Staff Report

File No.: SUB01-2023

Proposal: Preliminary Plat approval for a 14-lot subdivision

Address: 814/816 Toliver RD

**PRELIMINARY PLAT
 PUBLIC STREET &
 DRAINAGE PLAN**

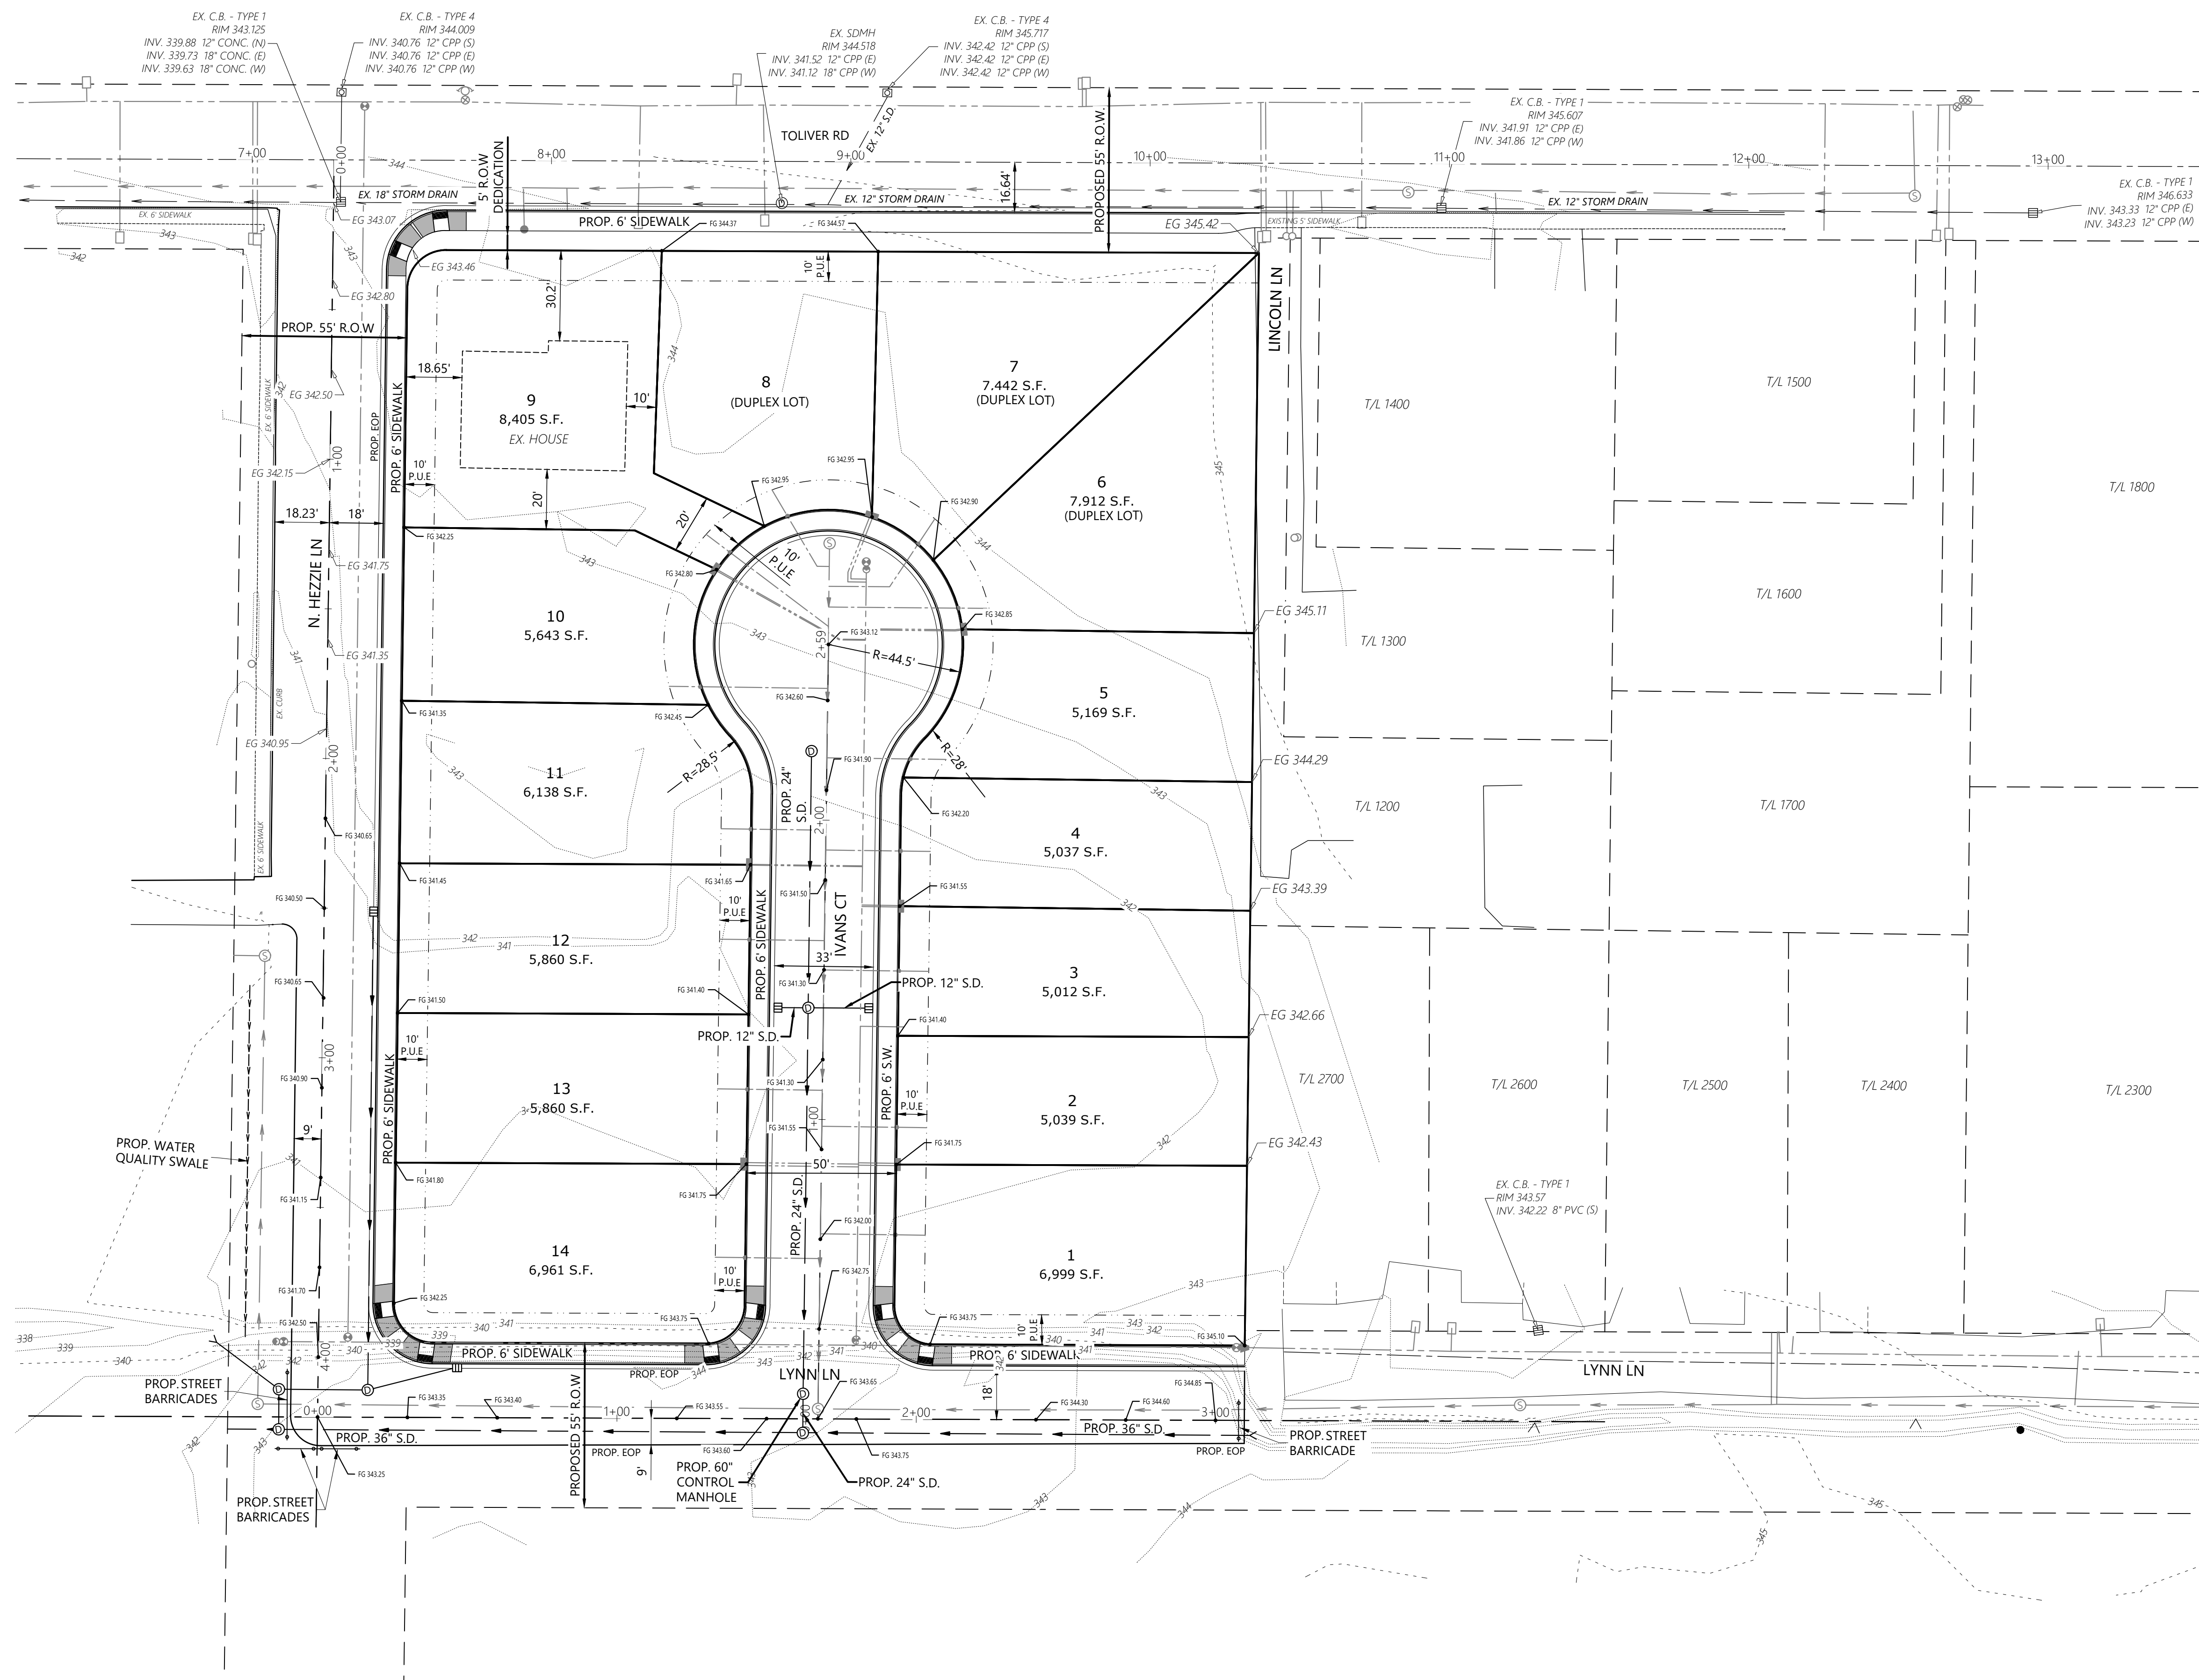
- viii. Given the radius on the plans, this appears to be an 89- foot diameter cul-de-sac. The minimum diameter is 96-foot for this road length. See OFC D103.4. Applicant shall confirm 96-foot radius or explain reduction in diameter and how the required diameter will be achieved.

- xiii. Applicant proposes barriers between the existing and proposed portions of Lynn LN since the existing portion only contains twenty feet of paved width and may not be able to accommodate traffic from the development. Feasibility of connecting these two sections with this development will be considered in civil plan review.

- 2) Given the radius on the plans, this will appear to be an 89- foot diameter cul-de-sac. The minimum diameter is 96-foot for this road length. See OFC D103.4. Please explain why the reduction in diameter and how the required diameter will be achieved.

**PRELIMINARY PLAT
 PUBLIC UTILITY PLAN**

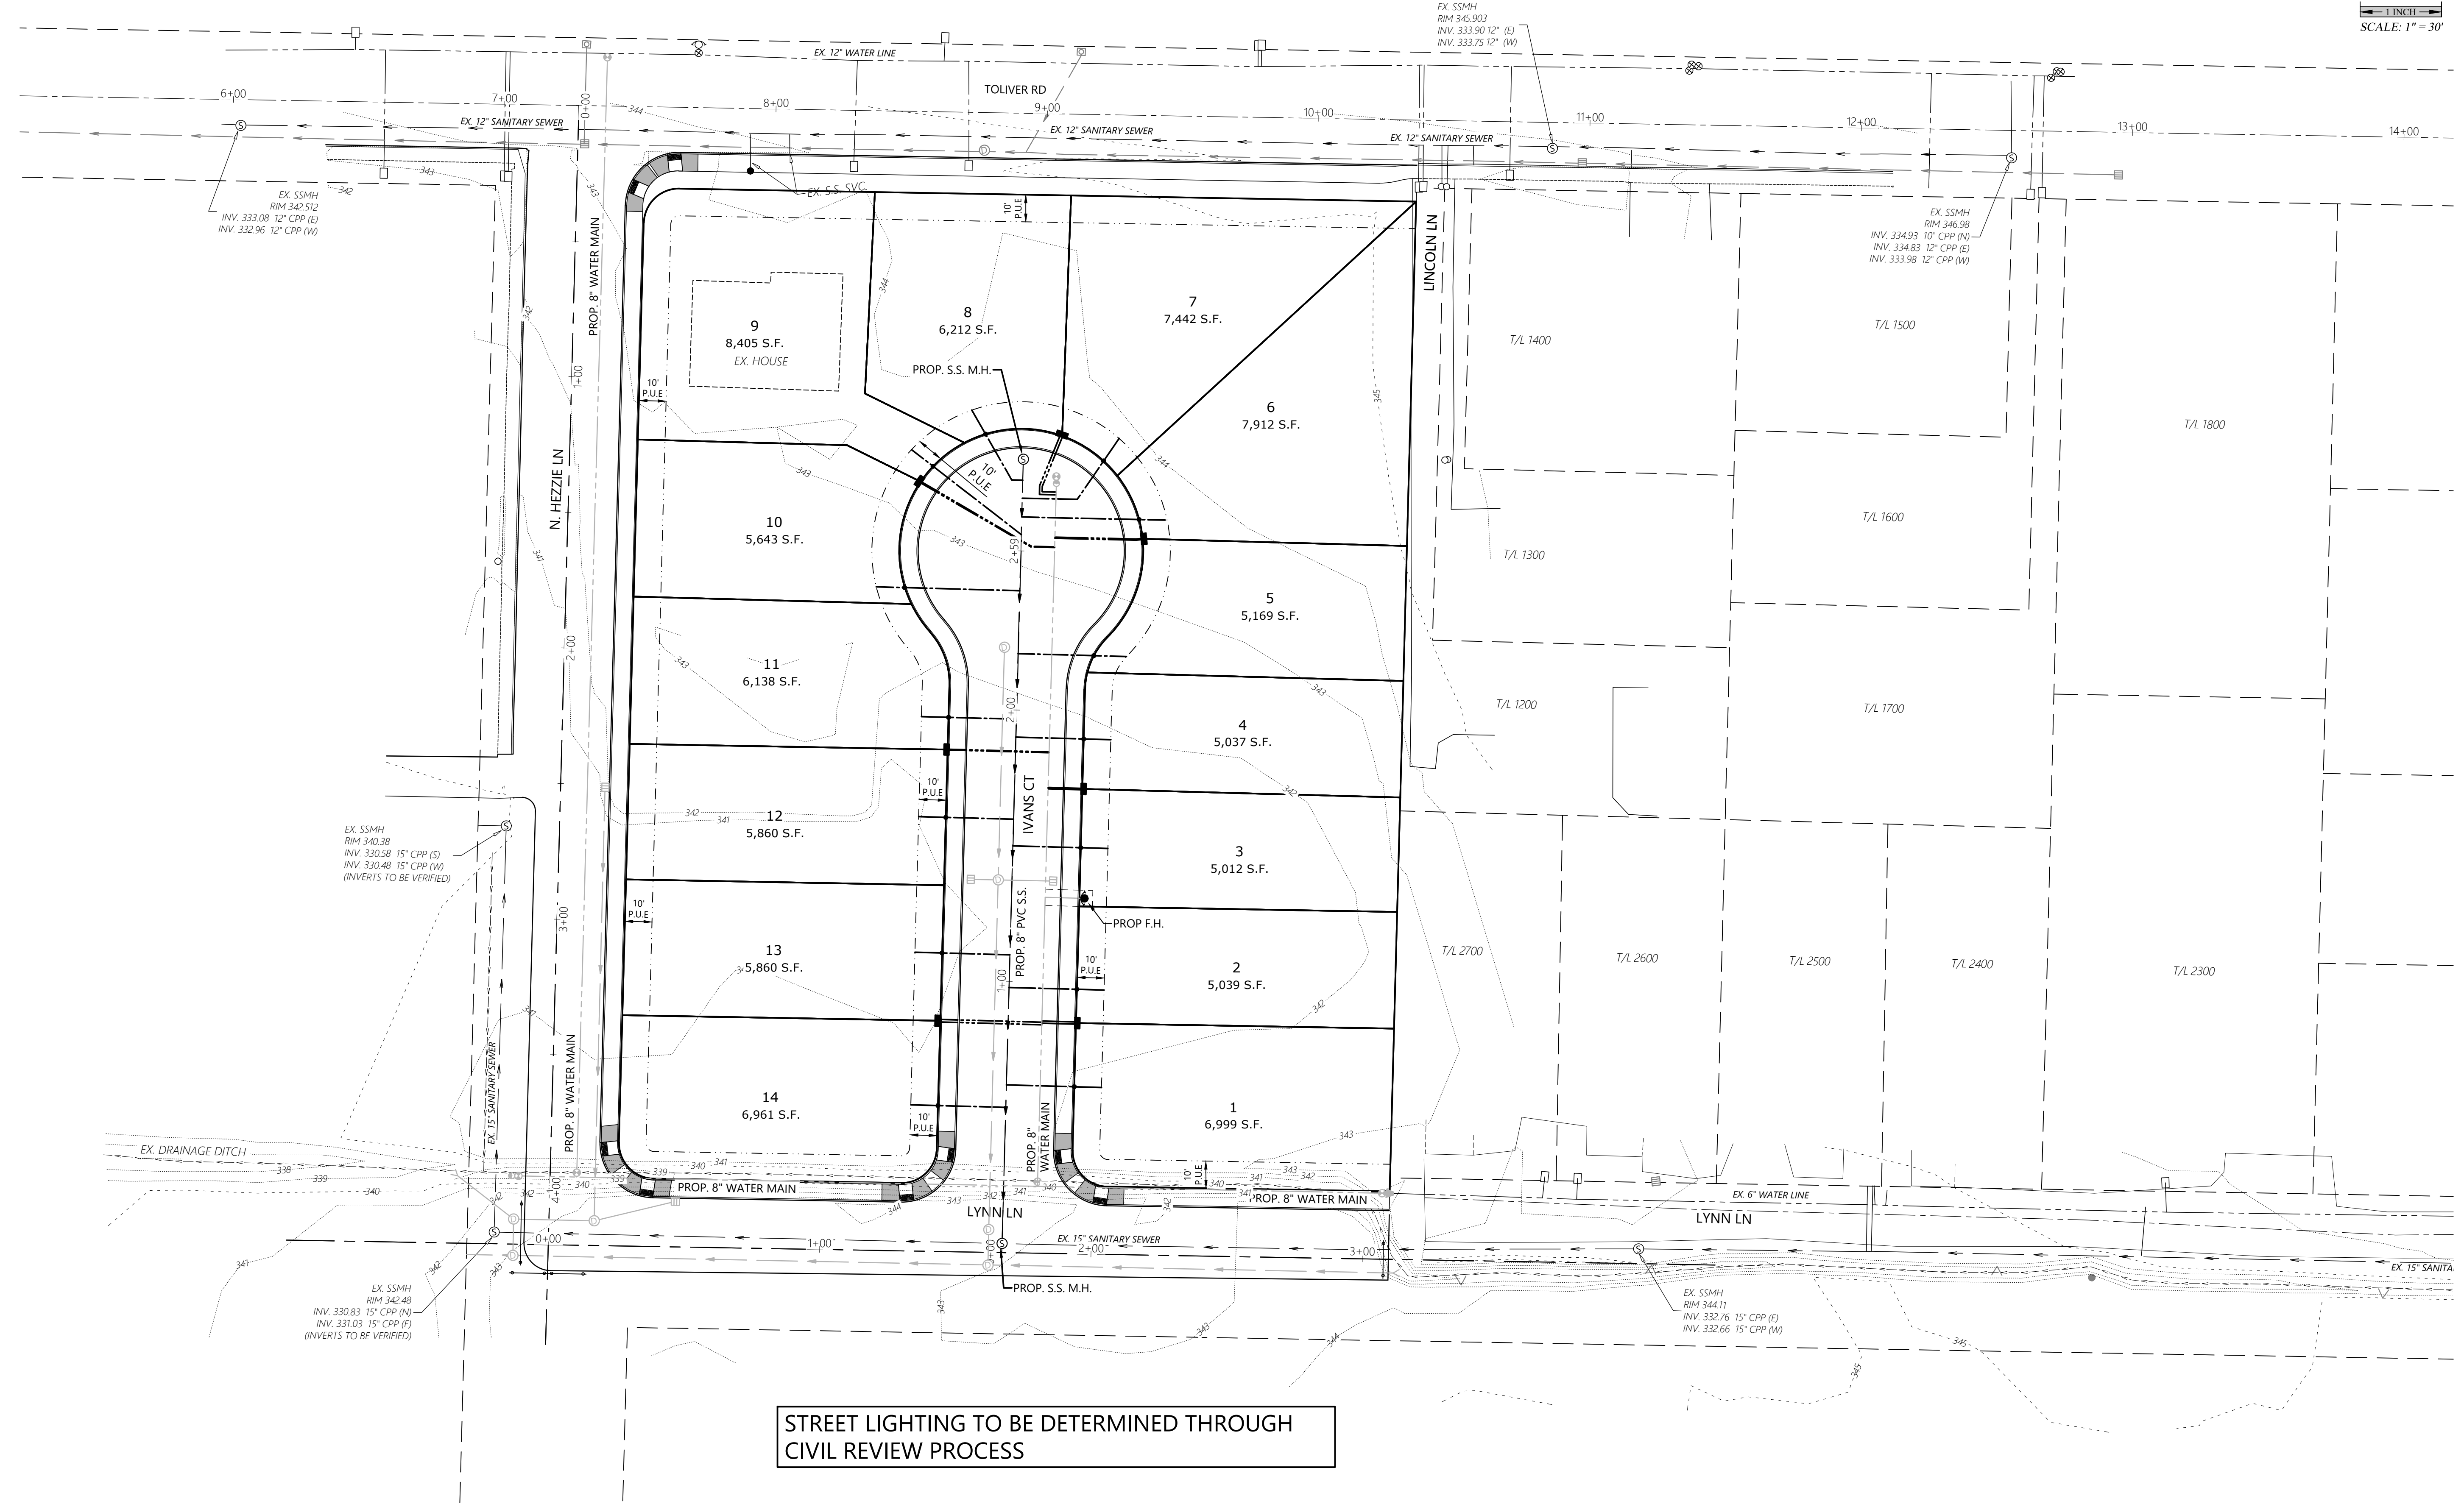
- vii. Applicant shall provide detail of hydrant extensions into subdivision for approval. See OFC Table C102.1. Pay close attention to the footnotes. Hydrants shall have a 4-inch sturtz fitting on the steamer port. Please note that Section D103.1 requires a specific road width for areas in front of hydrants. There is also a detail for achieving that area below this code site.

Water: A 12-inch water main exists within Toliver RD and will serve this development. Applicant shall extend an 8-inch main from the existing water main located in Toliver RD and connect to existing stub located within Lynn LN creating a looped system. Extensions for fire protection may be required and all public water lines shall be within a public easement on formats approved by the Public Works Department. Applicant's submitted utility plans meet these requirements. Should Fire Department regulations require additional fire flow that results in looping the water line through the site, then applicants engineer shall coordinate with Public Works for the extension of public waterline, and dedication of easements.

- 1) Please provide detail of hydrant extensions into subdivision for approval. See OFC Table C102.1. Pay close attention to the footnotes. Hydrants shall have a 4-inch storz fitting on the steamer port. Please note that Section D103.1 requires a specific road width for areas in front of hydrants. There is also a detail for achieving that area below this code site.
